MEMORANDUM DATE: May 6, 2020
AGENDA DATE: May 13, 2020
TO: Chair and Members of the Historic Resources Preservation Board
RE: **711 North L Street**
FROM: Jordan Hodges, Senior Preservation Coordinator
Abraham Fogel, Preservation Planner
Department for Community Sustainability

TITLE: **HRPB Project Number 20-00100067:** Consideration of a Certificate of Appropriateness (COA) for the new construction of a ± 2,245 square foot two-family structure at **711 North L Street**; 38-43-44-21-15-218-0140. The subject property is located in the Single-Family and Two-Family Residential (SF-TF 14) Zoning District and the Northeast Lucerne Local Historic District.

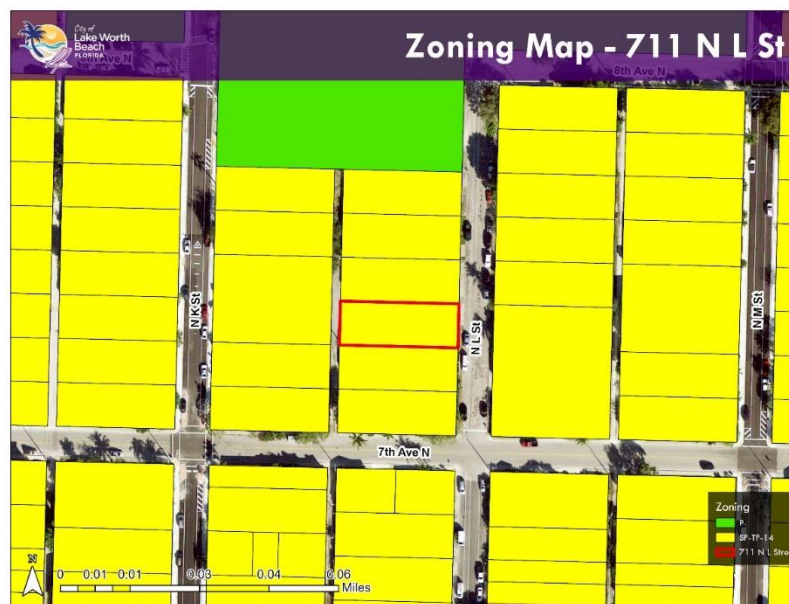
The Front Yard Impermeable Surface Total for the subject property is 250 square feet. The proposed site plan indicates that 255 square feet of the front yard will be impermeable. Staff has added a condition of approval so that the front yard would comply with the zoning requirement. This condition requires that a variety of pervious materials and driveway designs may be utilized to reduce the impermeable area and achieve compliance. The minimum dimensions for parallel parking spaces are 9'x22'. The proposed site plan indicates an 8'x20' parallel parking space is proposed. Staff has added a condition of approval that the rear parking space complies with the zoning requirement. There is sufficient space in the rear yard to accommodate the minimum parking dimensions. If the impermeable surface total for the lot becomes an

issue, since the additional lot coverage was not accounted for, the Applicant may utilize pervious materials to reduce the impermeable area.

- 11) The site plan shall be revised to comply with the front yard impermeable maximum.
- 12) The rear parallel parking space shall be revised to meet the minimum required dimensions.
